ECN/PCN No.: M1324

For Manufacturer			
<b>Product Description:</b> UNSHIELDED RADIAL POWER INDUCTOR	<b>Abracon Part Number / Part Series:</b> AIUR-06	<input type="checkbox"/> Documentation only	<input checked="" type="checkbox"/> Series
		<input checked="" type="checkbox"/> ECN	<input type="checkbox"/> Part Number
		<input type="checkbox"/> EOL	
<b>Affected Revision:</b> E	<b>New Revision:</b> F	<b>Application:</b>	<input type="checkbox"/> Safety
			<input checked="" type="checkbox"/> Non-Safety

# Unshielded Radial Power Inductor

## AIUR-06 Series

**4.0 Packing (100pcs / tray)**

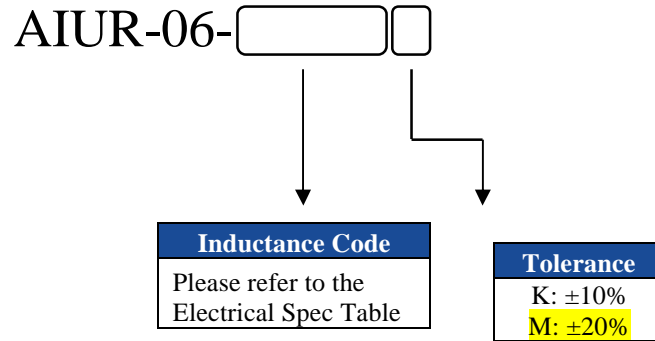
**Cause/Reason for Change:** Packaging was changed to (100pcs/tray) to prevent leads from bending; relaxed tolerance on 3R9, 4R7, 5R6, and 8R2; 'J' tolerance was discontinued. (Refer to **Partial EOL-ECN M1324 AIUR-06**)

Packaging: (100pcs / tray)
